**CITY OF OAKLAND**  
**AGENDA REPORT**

RE: REPORT AND RECOMMENDATION ON TREE PROTECTION MEASURES AND APPROVED BUILDING PLANS TO BE ADHERED TO DURING THE CONSTRUCTION OF A SINGLE FAMILY HOUSE AT 6036 CONTRA COSTA ROAD.

RESOLUTION TO AMEND RESOLUTION NO. 77953 C.M.S. AND TREE REMOVAL PERMIT DR01-154'S CONDITIONS OF APPROVAL REGARDING A TREE REMOVAL PERMIT APPEAL AT 6036 CONTRA COSTA ROAD

Site Map depicting Tree A, existing fence location, 12-foot perimeter fence requirement, proposed house and driveway locations and areas of conflict

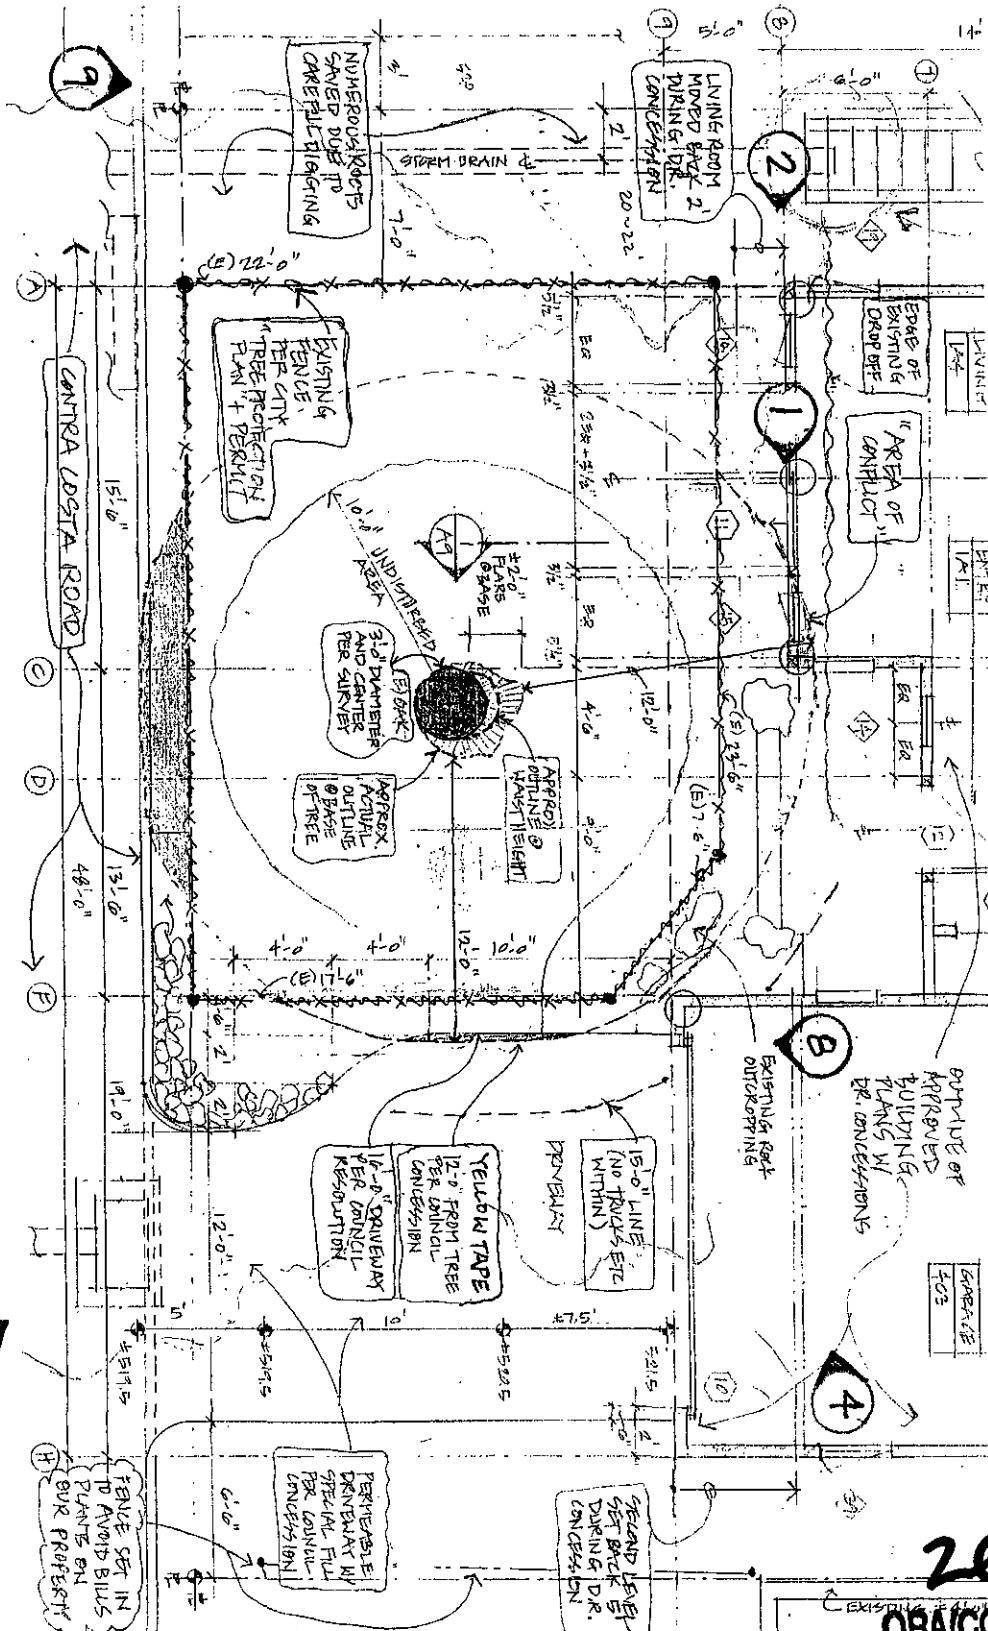
Two of the conditions listed in the permit conflict with the approved building plans. The tree protection fence, if installed at a 12-foot perimeter would prevent the installation of a foundation pier, grade beam and living room wall as shown on the building plan and would require the building to be redesigned. Secondly, the driveway cannot be built 16 foot wide without encroaching on the 12-foot protected perimeter.

The Tree Permit Conditions of Approval and the approved building plans conflict. The tree permit restricts construction within a 12-foot distance measured from the base of the tree and the approved building plan allows the right front corner of the living room to be located within this same space. Strict adherence to the tree permit conditions of approval would require a redesign of the home, moving the living room wall further back to be beyond 12 feet from the base of the tree. The driveway edge could not be built as a straight side, since the 12 foot perimeter encroaches into the edge of the driveway.

Rather than erecting the tree protection fence in a circular perimeter around the tree, which would require a larger number of posts to be driven and thereby possibly damaging roots, the fence was erected in a rectangular shape enclosing the tree on two sides at somewhat less than 12 feet, locating it on one side immediately inside the curb along the street and lastly being placed beyond sixteen feet on the remaining side. The existing rectangular-shaped tree protection fence encloses a 7.4 % larger root protection zone than that of a circular fence established at a 12-foot radius from the tree would.

Staff recommends that the existing fence (installed on two sides of the trees with less than a 12-foot perimeter) be permitted to serve as the protective tree fence, and that the owners be permitted to build the home according to the approved building plan, including allowing the driveway to be 16 feet wide at its entrance.

1. Allow the currently existing fence to serve as an adequate tree protection fence, thereby permitting the house to be built according to the approved building plans.
2. Since "significant roots" were not found to be within the driveway entrance zone, and the configuration of a 16-foot wide driveway has been determined to be safer and allow for more off street parking on a narrow road with limited parking, the driveway shall be 16 feet wide for its entire length.
3. A flagstone path will be permitted to be laid on a sand and gravel base leading from the driveway to the front concrete porch. This shall be done only after all other construction has been completed and the tree protection fence has been approved to be removed by the Tree Services Section.
4. Oak tree "C" in the rear of the proposed home shall not require a tree protection fence to be installed.
